MY3 FINAL MONITORING REPORT
Odell's House Buffer Mitigation Project
Monitoring Year 3
Calendar Year of Data Collection: 2023

NCDEQ DMS Project Identification #100041
NCDEQ DMS Contract # 7420
Neuse River Basin (CU 03020201)
DWR Project # 2018-0200
USACE Action ID Number: SAW-2018-00431
Johnston County, NC
Data Collection Period: March and September 2023
Submission Date: December 2023

RE: WLS Responses to NCDEQ DMS Review Comments for Task 9 Submittal, Draft Monitoring Year 3 Report for the Odell's House Mitigation Project, DMS Full-Delivery Project ID #100041, Contract #7420, Neuse River Basin, Cataloging Unit 03020201, Johnston County, NC

FIGURE
2a

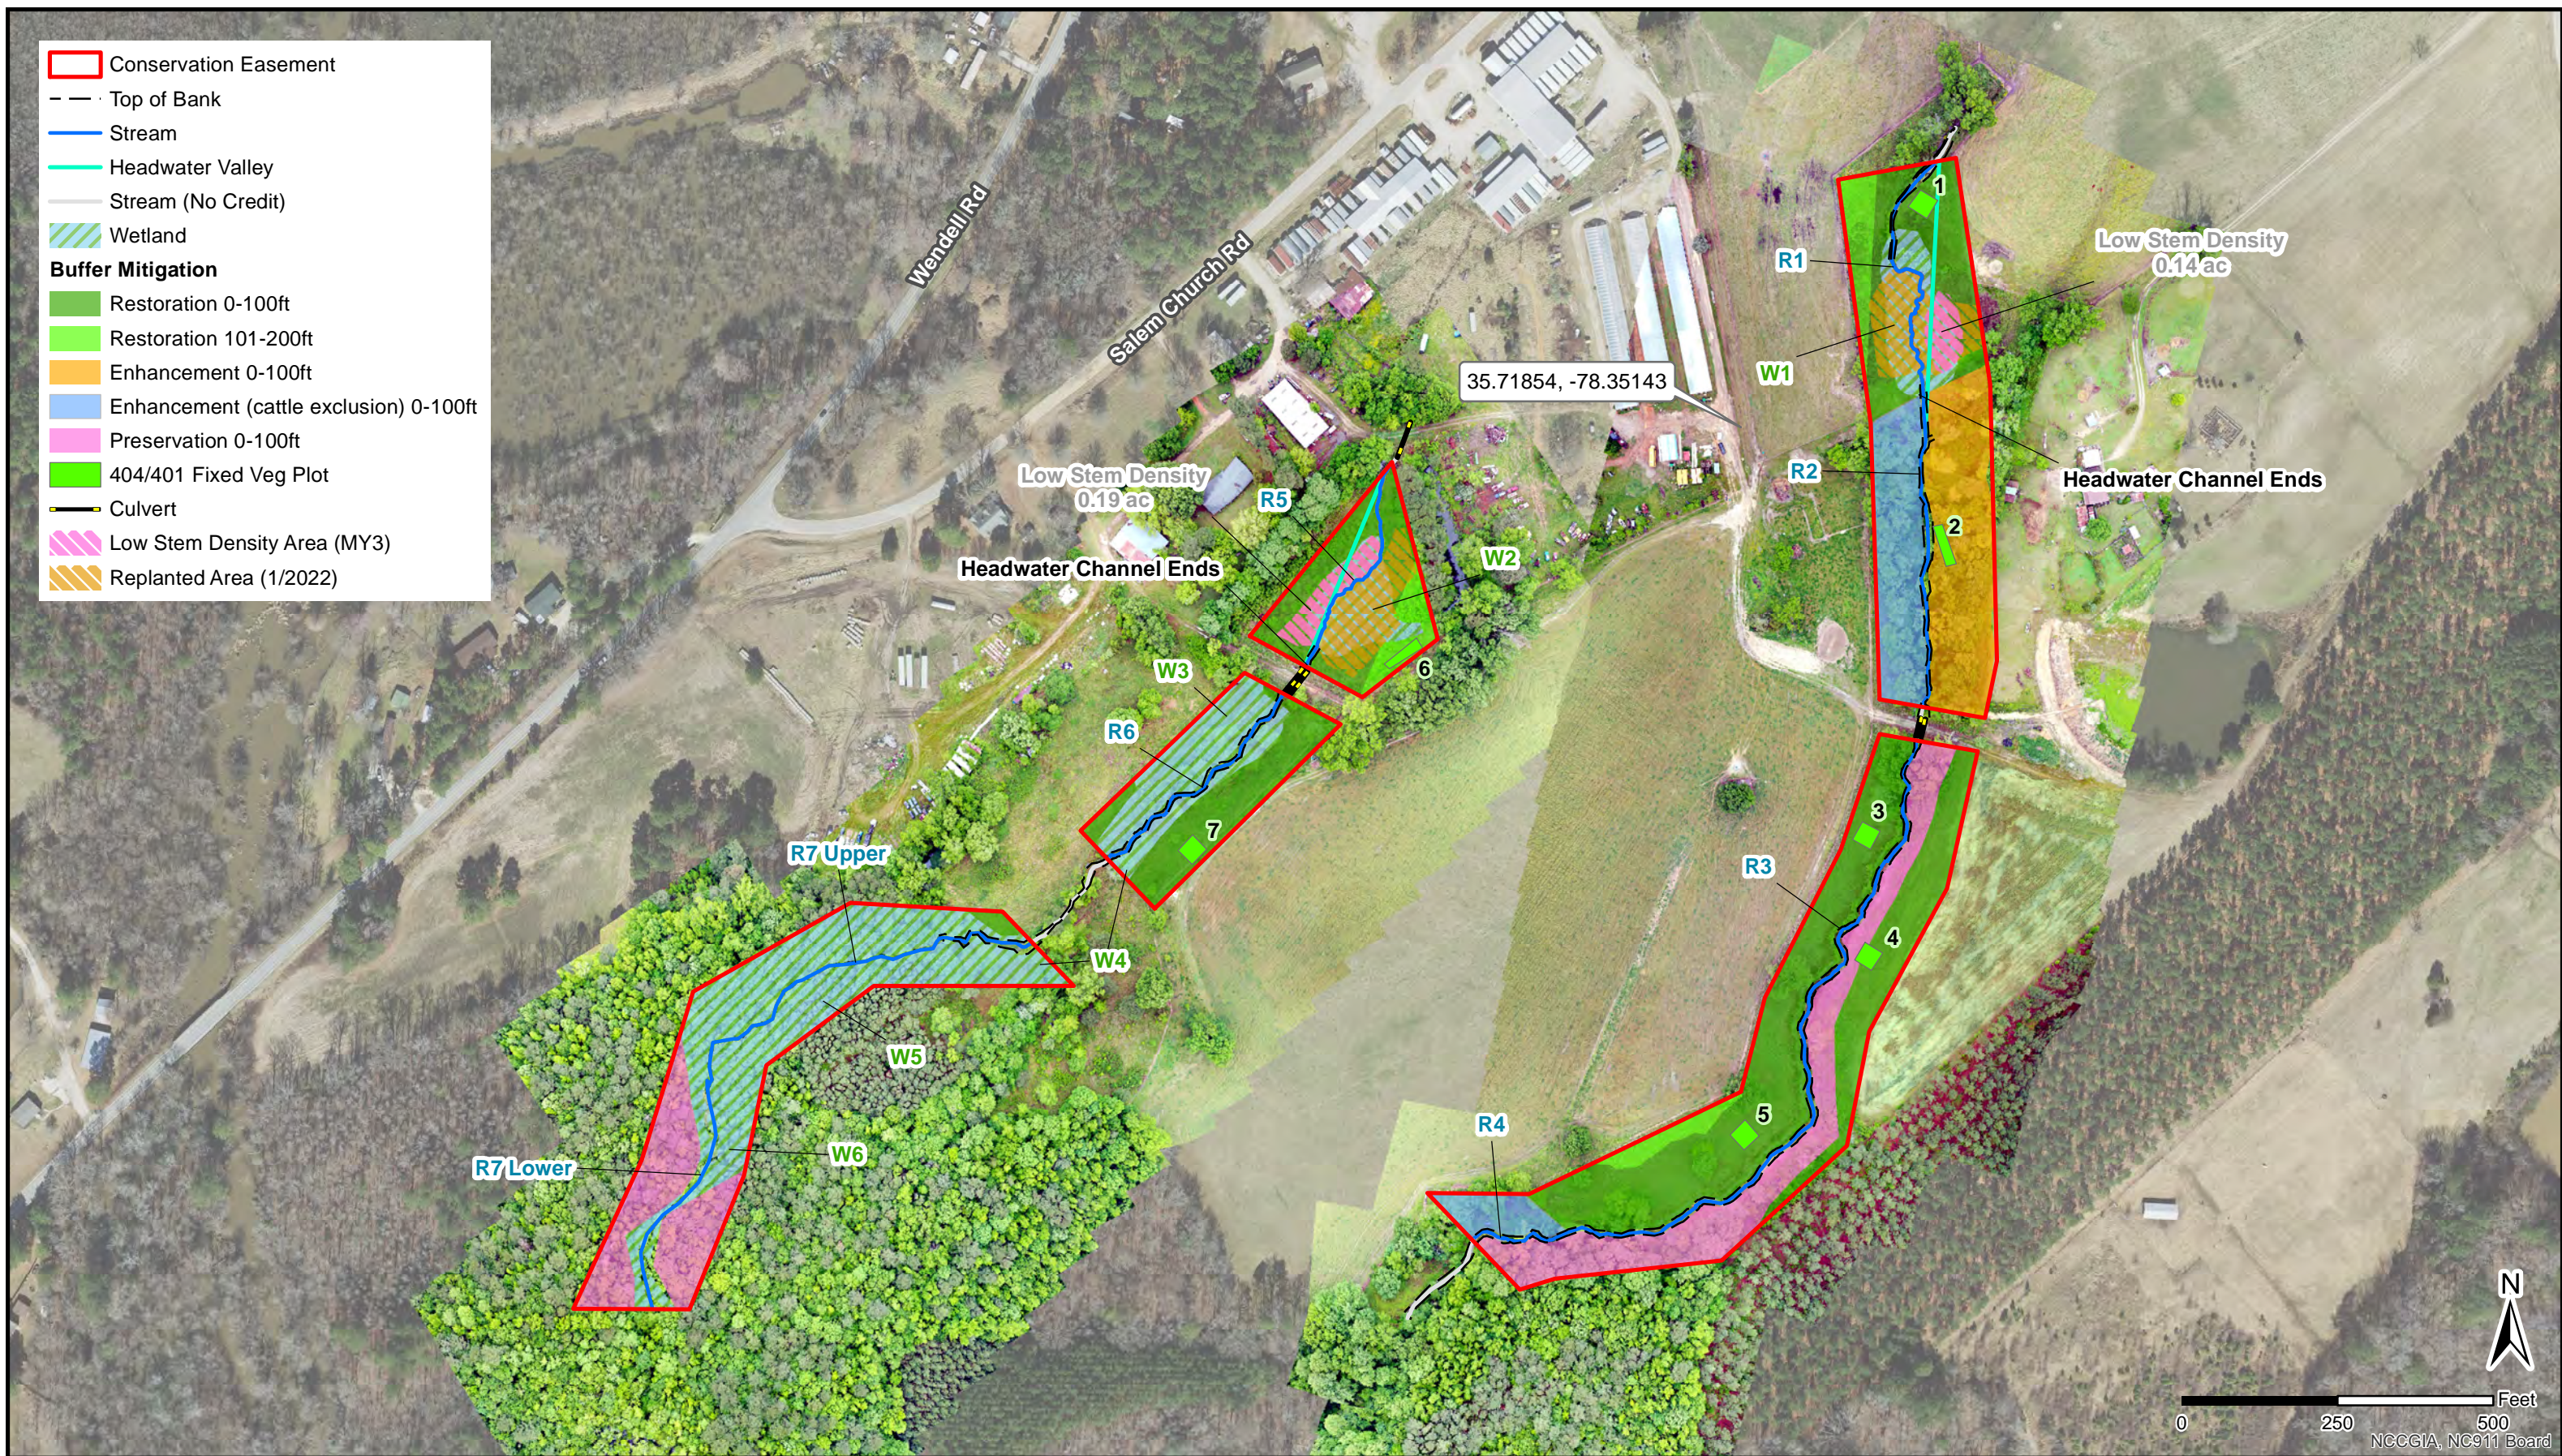
1. **Figure 1b: Add date to replanted area in legend (1/2022).** WLS Response: The date has been added to the replanted area in the Figure 1b legend.
2. **Figure 1b: Is the low stem density area the same as it was in MY2? Indicate if this is true by adding MY3 in legend.** WLS Response: The low stem density area is the same as it was in MY2 and the legend on Figure 1b and c have been updated accordingly.
3. **Appendix A, Vegetation Condition Assessment Table: Update low stem acreage to 0.33 acres.** WLS Response: The low stem acreage has been updated to the correct acreage in the Appendix A, Vegetation Condition Assessment Table.
